RE: 64 BATHURST STREET LIVERPOOL - KEY STUDY FINDINGS

e8urban were commissioned to prepared an independent urban design study to assess the potential impacts of a proposed DA for 64 Bathurst Street - Lot 10 DP 816556 (The Site) on the surrounding sites in the context of the Liverpool Development Control Plan 2008 Part 4 Development in Liverpool City Centre (The DCP) and other relevant planning design guidance.

SK-0037 to SK-0040

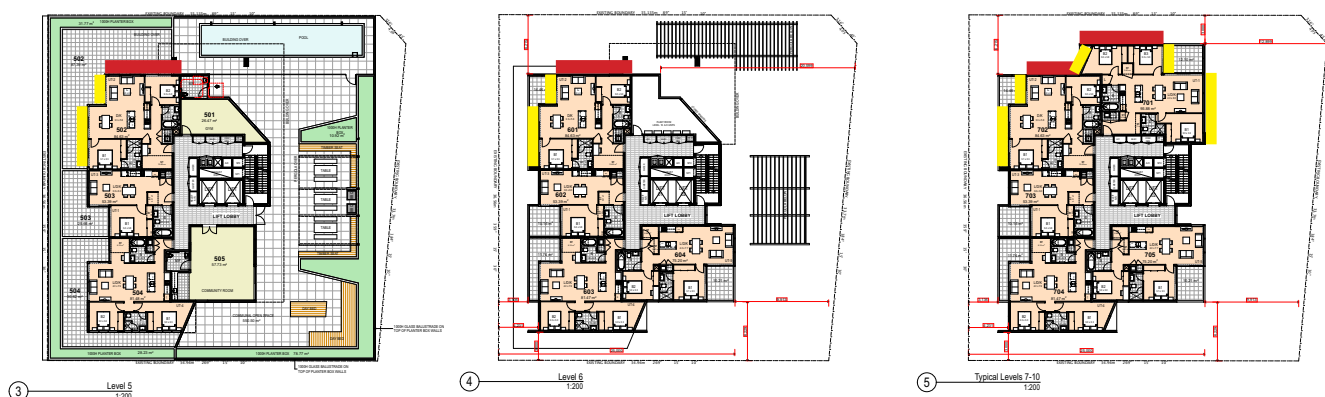
These drawings show the overshadowing impact of the four options that have been tested. In each drawing the area of building facade of the proposed development to 64 Bathurst Street that would receive less that two hours of direct sunlight has been identified.

The plans below show these zones (red potential for less than two hours direct sunlight and yellow area that would receive greater than 2 hours of direct sunlight as per the ADG), and highlight how the internal planning of the units means that the main habitable spaces would still receive 2 hours of direct sunlight - This is based on the worst case scenario, that being Scheme 1 where six serviced apartments are impacted mid-winter; this equates to 6% of the total 101 residential units and serviced apartments.

Based on the orientation of Building 3, it is reasonable to assume that the internal planing of the

development above the podium level could be arranged to ensure solar access requirements are met.
